Access Compliance Report

Public Rights-of-Way

(Curb Ramps)

Intersection ID: 10036752	Main Street: S_HOSKINS_RD	Cross Street: N/A	Location: SW
ADA ID: 3C51219B817F	Ramp Type: Perp	Initial Pass/Fail: Pass	Overall Compliance: No
Codes/Mitigation Info/Possible Solution		Field Measurements/Component Compliance	
		Severity Score: 10

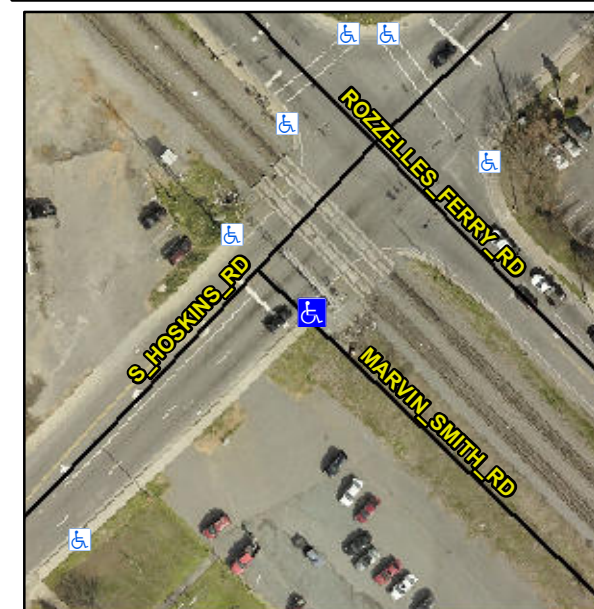
R304.2.1, R305

Compliance	Description	Data	Compliance	Description	Data
N/A	Ramp Length (in)	70.5	Yes	Ramp Slope (%)	7.0
Yes	Ramp Width (in)	59.5	Yes	Ramp XSlope (%)	0.7
N/A	Flare Type LT	None	N/A	Flare Type RT	N/A
N/A	Flare Slope LT (%)	N/A	N/A	Flare Slope RT (%)	N/A
N/A	Flare Traversable LT?	N/A	N/A	Flare Traversable RT?	N/A
No	Landing Length (in)	43.5	No	DWS Provided?	No
Yes	Landing Width (in)	59.5	N/A	DWS Contrast?	No
Yes	Landing Slope (%)	0.4	N/A	DWS Length (in)	N/A
Yes	Landing X Slope (%)	1.4	N/A	DWS Full Width?	No
N/A	Landing Curb? (Y/N)	No	N/A	DWS Offset (in)	N/A
N/A	Shared Landing?	No			
Yes	Gutter Ponding?	No	Yes	Gutter Slope (%)	0.2
Yes	Gutter Lip Ht (in)	0.0	Yes	Gutter X Slope (%)	1.3
N/A	Painted X Walk1?	No	N/A	Painted X Walk2?	N/A
	X Walk 1 Direction	To NE		X Walk 2 Direction	N/A
N/A	X Walk 1 Width (in)	N/A	N/A	X Walk 2 Width (in)	N/A
	X Walk 1 Slope (%)	2.3		X Walk 2 Slope (%)	N/A
	X Walk 1 X Slope (%)	1.1		X Walk 2 X Slope (%)	N/A

Remove & Replace Entire Ramp.
